CONCORDIA CAMPUS RESIDENCE HALL

11400 CONCORDIA UNIVERSITY DRIVE
AUSTIN, TX 78726
SP-2020-0038C

Concordia Campus Residence Hall SP-2020-0038C

VARIANCE REQUEST

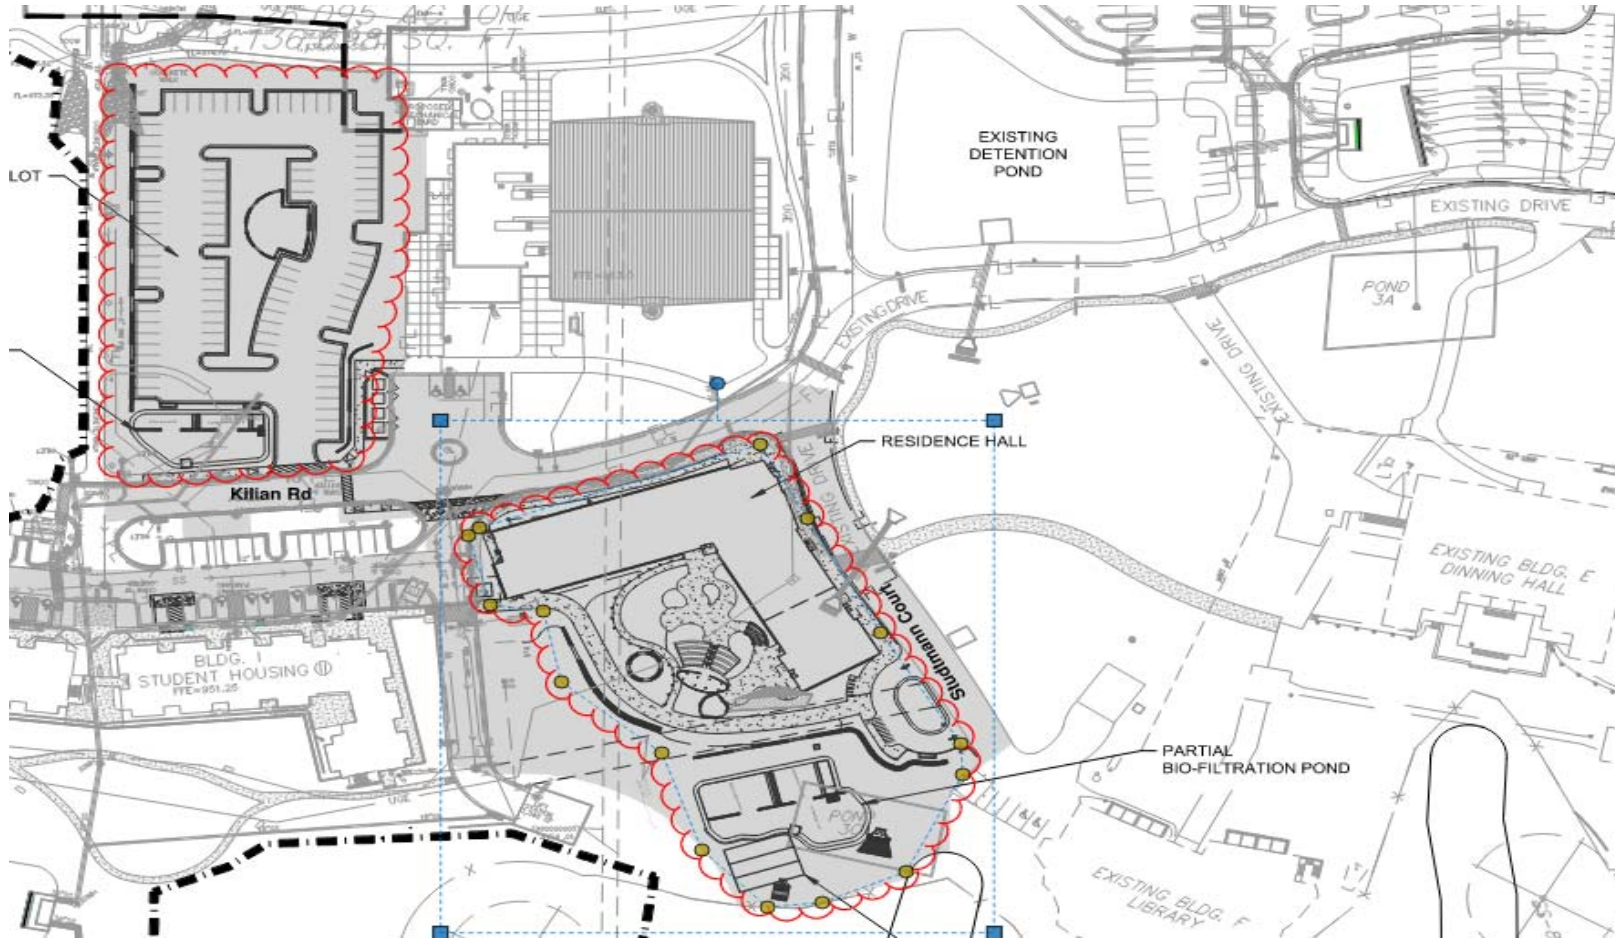
1. Are there special circumstances applicable to the property involved where strict application deprives such property owner of privileges or safety enjoyed by other similarly situated property with similarly timed development?

Staff Determination: Yes

In site plan case #SP-2007-0231C, a variance to Lake Austin Ordinance #840301-F, Sections 9-10-409(a) and 9-10-409(b) was granted for a max cut of +/-5.8' and a max fill of +/- 17.5' to construct a parking area, baseball field, and fieldhouse. Thereafter, a variance to vary from the same code sections was granted for a max cut of +/-9.25' and a max fill of +/- 14.85' to construct a water quality and detention facility, a water quality channel, a softball field, and associated parking in site plan case #SP-2013-0476C.

FILL EXHIBIT

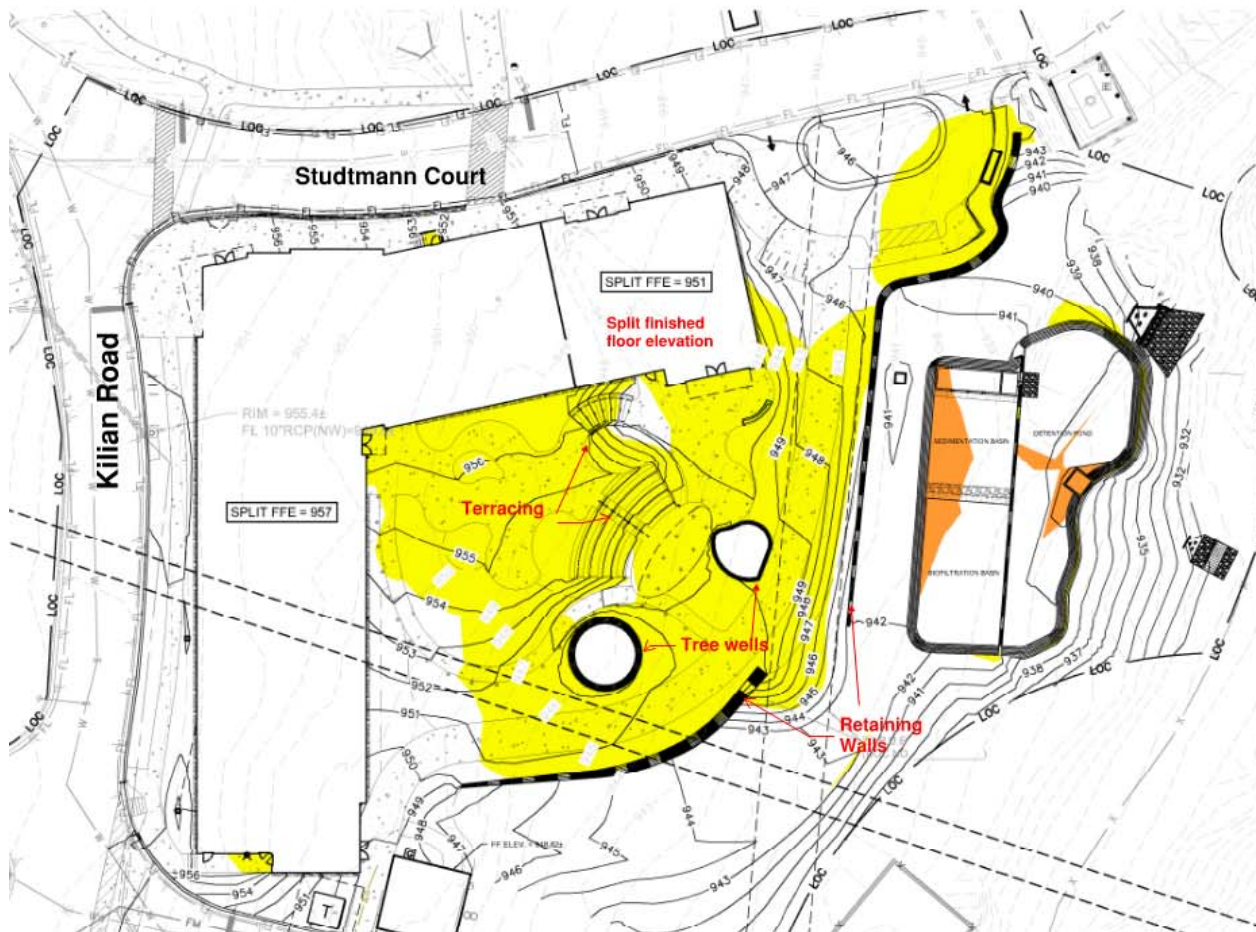
2. Does the project demonstrate minimum departures from the terms of the ordinance necessary to avoid such deprivation of privileges enjoyed by such other property and to facilitate a reasonable use, and which will not create significant probabilities of harmful environmental consequences?

Staff Determination: Yes

The residence hall and associated improvements are located on a site with subtle topography and encompassed by existing development. The residence hall and associated improvements are positioned at the intersection of Kilian Road and Studtmann Court and are constructed to meet the elevation of the existing driveways and sidewalks for connectivity and access. As such, there is a six foot change in grade between the existing topography at the rear of the building and the finished floor elevation. Ergo, fill between four and eight feet is necessary to prevent a dramatic change in grade from the building to the courtyard and to meet ADA requirements. For the associated residence hall loading and unloading driveway off of Studtmann Court, fill between four and five is necessary to match the existing grade of Studtmann Court. To alleviate the amount of fill, terracing techniques, tree wells, and retaining walls are incorporated in the design of the courtyard and adjacent driveway. Moreover, a portion of the building has been set to a lower finished floor elevation where grades are naturally downslope to further reduce the amount of fill.

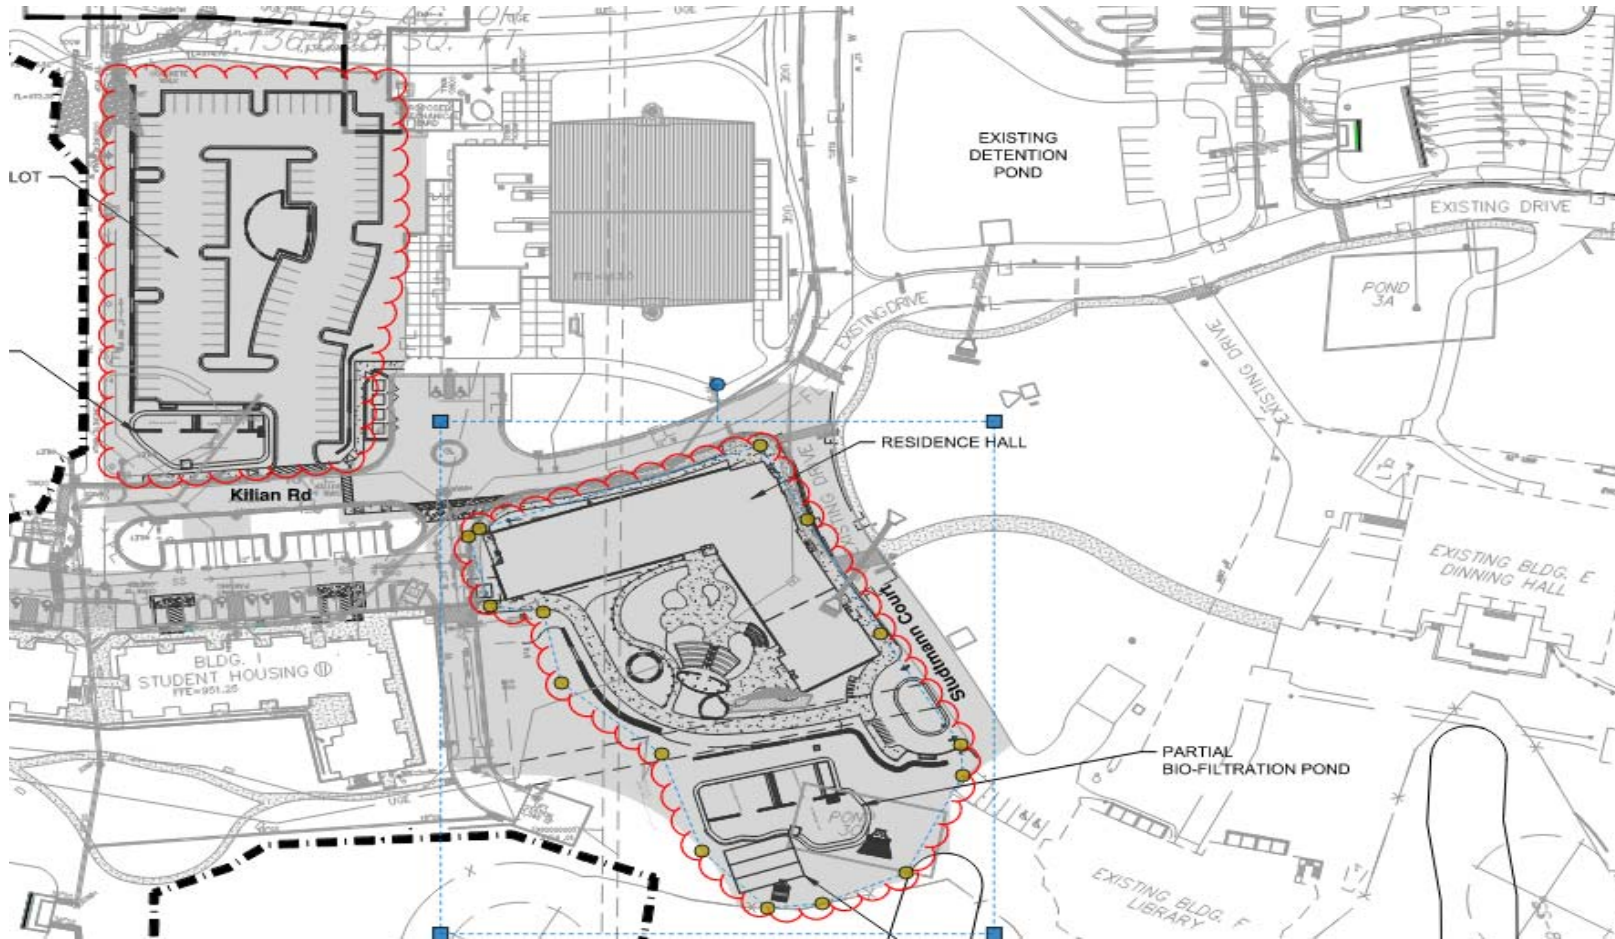
1. Are there special circumstances applicable to the property involved where strict application deprives such property owner of privileges or safety enjoyed by other similarly situated property with similarly timed development?

Staff Determination: Yes

In site plan case #SP-2007-0231C, a variance to Lake Austin Ordinance #840301-F, Sections 9-10-409(a) and 9-10-409(b) was granted for a max cut of +/-5.8' and a max fill of +/- 17.5' to construct a parking area, baseball field, and fieldhouse. Thereafter, a variance to vary from the same code sections was granted for a max cut of +/-9.25' and a max fill of +/- 14.85' to construct a water quality and detention facility, a water quality channel, a softball field, and associated parking in site plan case #SP-2013-0476C.

CUT EXHIBIT

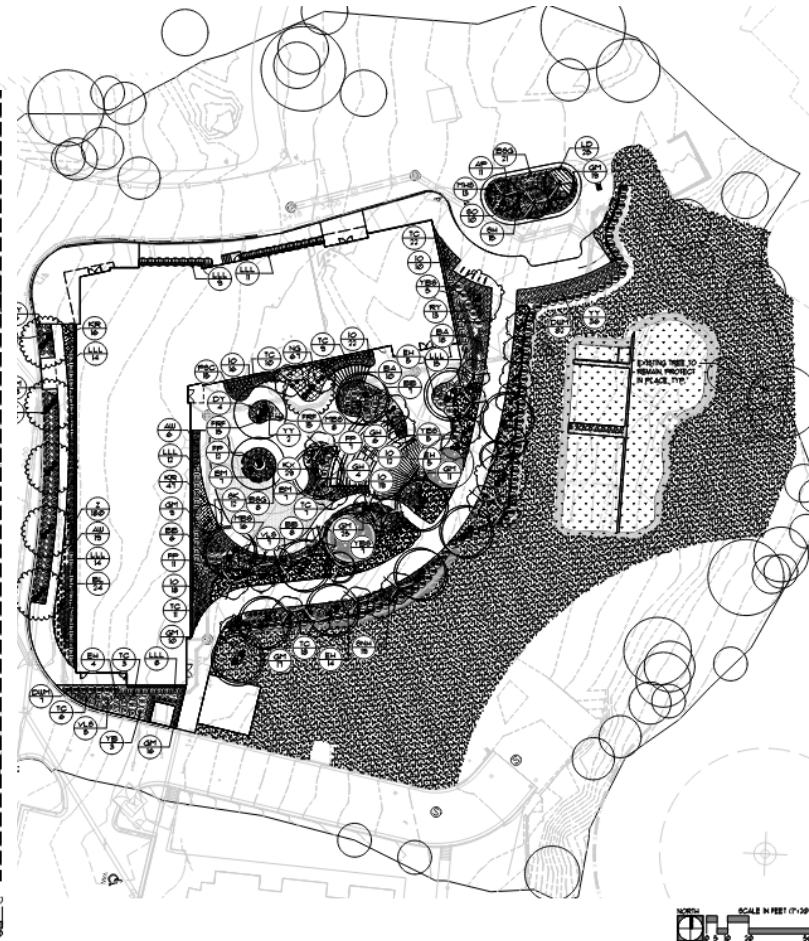
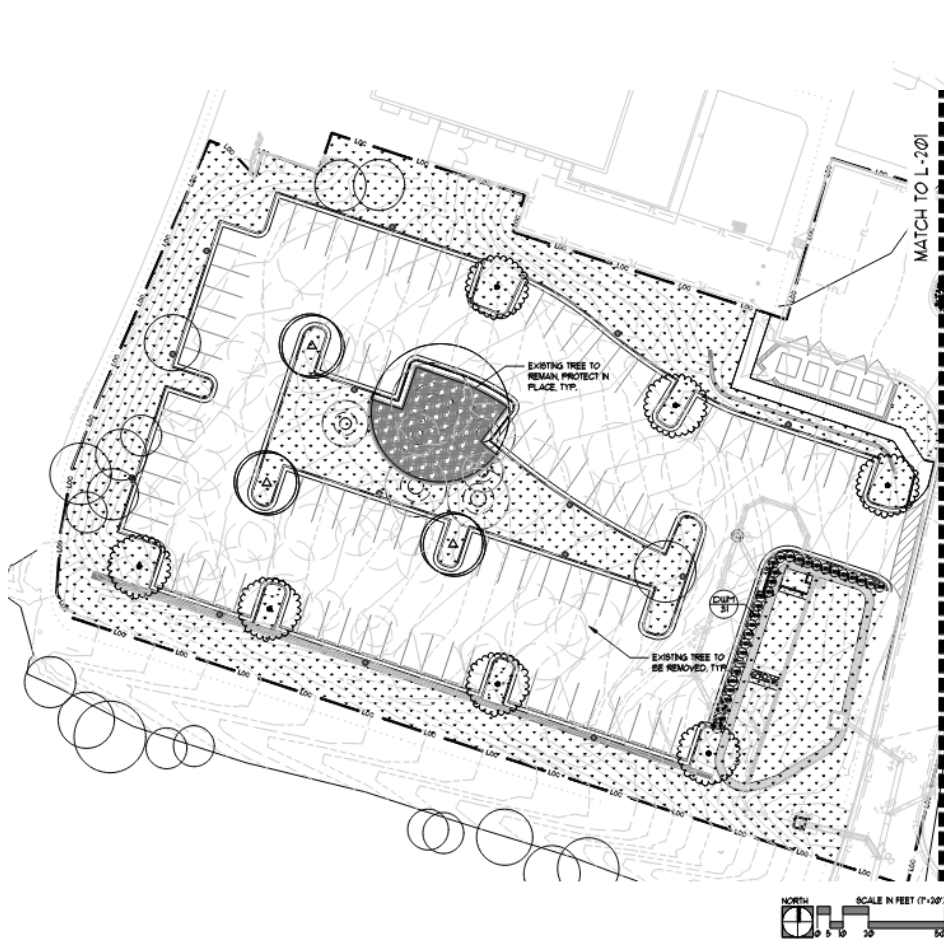
2. Does the project demonstrate minimum departures from the terms of the ordinance necessary to avoid such deprivation of privileges enjoyed by such other property and to facilitate a reasonable use, and which will not create significant probabilities of harmful environmental consequences?

Staff Determination: Yes

The proposed parking lot, residence hall, and associated improvements are located on a site with subtle topography and encompassed by existing development. The driveway approach for the parking lot must be constructed to match Kilian Road elevation as the only ingress and egress to the parking lot is off Kilian Road. Moreover, proposed grades follow the natural contours to the best extent possible to maintain the natural drainage patterns for the capturing of runoff into the proposed water quality and detention ponds located at the low point of the parking lot. As a result, cut exceeding the allowable four feet is required for a gentle slope transition for the internal circulation of the parking lot and for drainage and water quality purposes. Additionally, to adequately treat the residence hall and associated improvements, the existing sedimentation and detention ponds require a max cut of six feet for upgrades, including the addition of a bio-filtration pond.
